**Agilent 5071A Primary Frequency Standard
Telecommunications Options**

**Telecommunications
Options Supplemental
Manual**

Options: 048, 104, 105, 220, 221, 222, 270, 271, and 272

**Manual part number
05071-90042**

5071A Rear Panel Connections

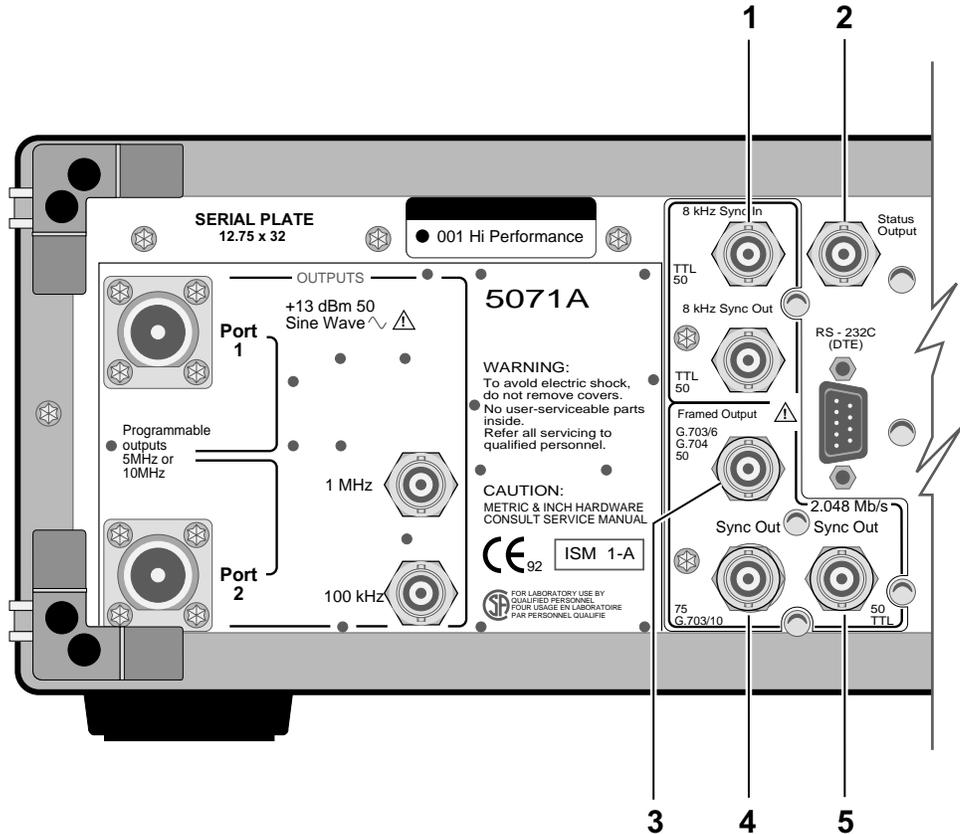
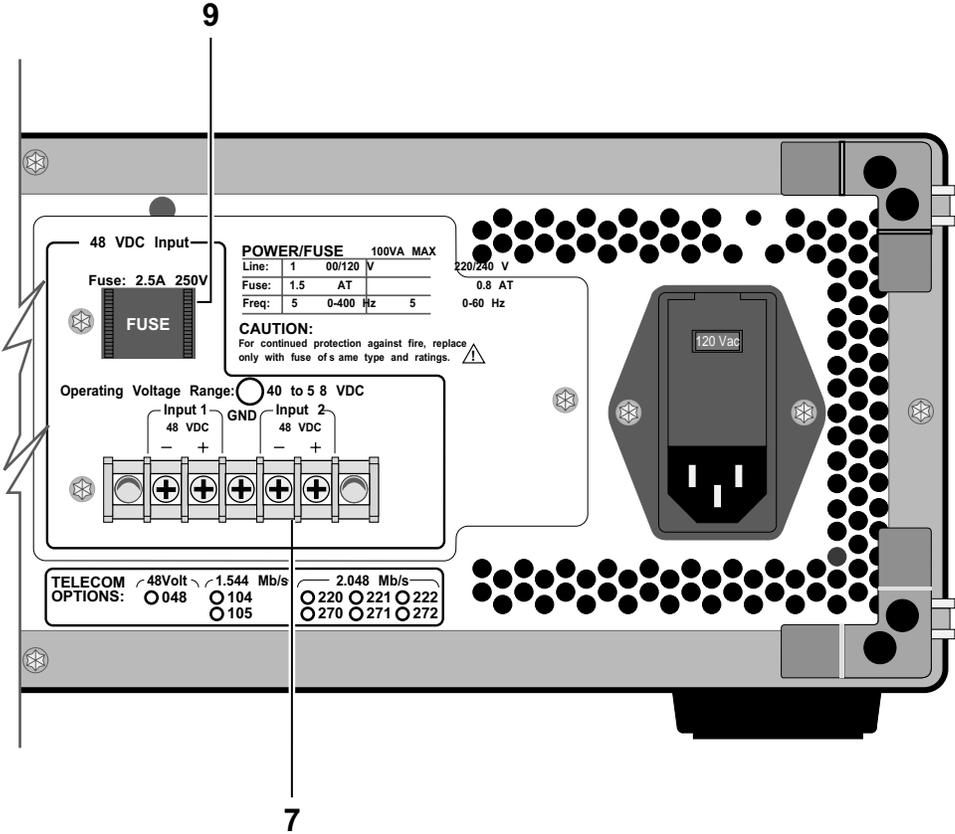
Any TCO Option: Items 5 and 6 are absent from the rear-panel.

Option 048: Item 9 is absent.

Item 10 Connector Type is a 5-screw terminal strip.

Item 10 Signal Characteristics are 40-58 Vdc on the rear-panel terminal strip dc-power inputs 1 and/or 2 with GND as chassis ground.

Figure 2-1. DC Input 1 and 2 Power Steering Schematic (48V Subpanel Assembly, part number 05071-60277)

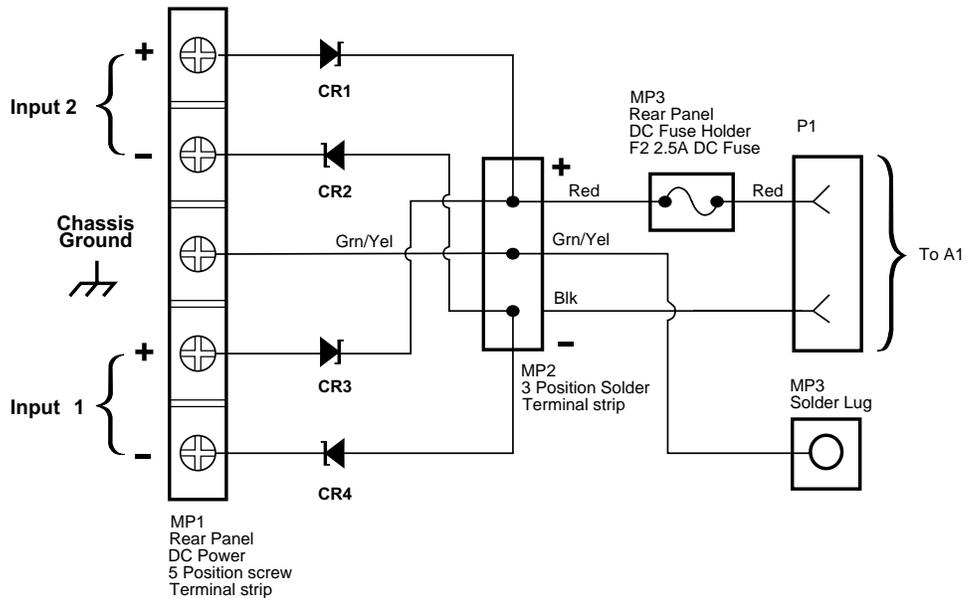
Refer to Figure 2-1 for a schematic diagram of the five-screw dc input terminal strip and associated power steering diodes for dc power input 1 and input 2.

The schematic diagram in figure 2-1 below illustrates the wiring of the 48V Subpanel Assembly. This assembly steers dc input power, and provides fuse protection for the external 48V external dc input power. The output of this circuit at P1 is routed to the input of the External DC Input Filter Block (J1) illustrated at the top-left corner of figure 3-3. in the 5071A Assembly-Level Service manual.

Option 048: The 48V Subpanel Assembly illustrated by the schematic diagram shown in Figure 2-1 is part number 05071-60277.
